TCAF Validation Report

Title of the TCAF Program subject to validation	UZBEKISTAN: INNOVATIVE CARBON RESOURCE APPLICATION FOR ENERGY TRANSITION PROJECT
Addressee of the Validation Report	Transformative Carbon Asset Facility (TCAF)
Version number of the Validation Report	2.1
Completion date of the version	25/05/2023
Name and location of Validator	AENOR INTERNACIONAL S.A.U. (AENOR) Génova, 6. 28004 Madrid Spain Telephone +34 914326000 larribas@aenor.com; medioambiente@aenor.com www.aenor.com
Statement that the Host Country is responsible for the preparation and fair presentation of the CPDD in accordance with the criteria	The Government of Uzbekistan has submitted the CPDD for validation.
Statement that the validator is responsible for expressing an opinion on the CPDD based on the validation	AENOR is responsible for expressing the opinion on the CPDD based on the validation process described in this validation report. AENOR has validated that the “Uzbekistan-Innovative Carbon Resource Application for Energy Transition Project” is in compliance with the TCAF requirements. The methodology developed for the program (Methodology and Model for ex-post quantification of CO2 emissions imp

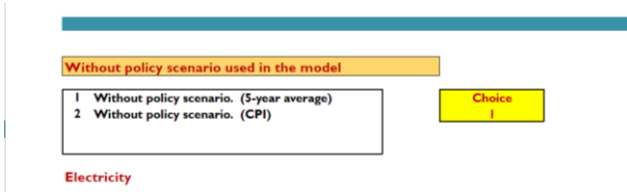
CR ID	04	Date: 13/03/2023
Description of the CR		
Clarify the reason because different impact channels are identified in different sections of the C-PDD, such as section 8.1, impact channels section of the methodology in pages 50-51 and section “Chapter 2: Impact Channels” in pages 61-62.		
Project Participant response	Date: 12/04/2023	
They are essentially the same but different language is used to express the same concept. The language can be revised if necessary.		
Documentation provided by the Project participant		
CPDD V3		
VVB Assessment	Date: 28/04/2023	
Section 8.1 refers only five impact channels, page 53 refers eight and chapter 2 refers nine. Therefore, the reason is not only the use of different language, and the impact channels identified shall be clarified in the different sections of the document.		
Project Participant response	Date: 02/05/2023

<p>In total, the methodology takes into account 9 impact channels:</p> <p>As provided in the page 65 of the methodology, channels one to four focus on the final consumption of energy (by the end-user) which is the case for this proposed program, channel 5 is included too because it covers the impact of an increase in fuel prices for all on- and off-grid generating units when grid-supplied electricity price does not change and end-user prices of other fuels do not change.</p> <p>Channels six to nine are exclusively for looking at the impacts of price changes on grid-based electricity generation which is not the case for the program and therefore those channels are not applicable.</p> <p>The 8 impact channels on page 53, the language have been edited to reflect the remaining 4 channels relevant to power sector.</p>	
<p>Documentation provided by the Project Participant</p>	
<p>Updated CPDD V5</p>

<p>VVB Assessment</p>	<p>Date: 22/05/2023</p>
<p>TCAF Host Country has clarified that the program has five impact channels of all possible impacts channels identified by the methodology.</p> <p>Therefore, the CR is closed.</p>

Uzbekistan Energy Policy MRV model

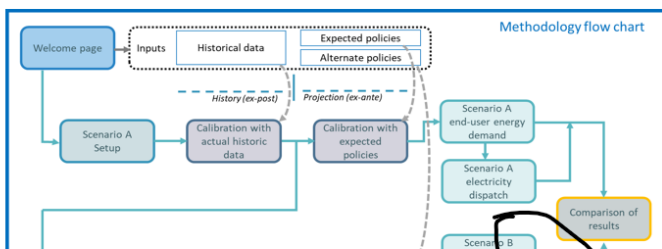
VVB Assessment	Date: 28/04/2023
<p>The change of the value from 30 MtCO₂e to 86.7 MtCO₂e is very significant. Please, clarify the reasons of the change.</p> <p>We cannot find the “Calc. Prices” sheet into the spreadsheet.</p>	
Project Participant response	Date: 05/08/2023
<p>The most recent adjustment to the model was to base the calculations on data sourced from Uzbekistan wherever possible instead of international agencies (such as the IEA). Part of this change was to use the ex-ante pricing forecasts from the Ministry which show more aggressive tariff increases than those previously supplied by the World Bank Energy GP. The results will be monitored and verified ex-post based on the actual tariffs.</p> <p>To see all the tabs, the user must click on the “hide/show default Excel functionality” button. Once the tabs are shown, the “Calc.Prices table is the 6th sheet in the file. Additionally, to see the data and run the file properly, Macros must be enabled.</p>

VVB Assessment	Date: 22/05/2023
<p>The different information included in the final version of the C-PDD is now consistent between them and with the final version of the “Energy Policy MRV model” provided in the spreadsheet “UZB_NewEnergyPolicyMRV v23updated”.</p> <p>Therefore, CR is closed.</p>
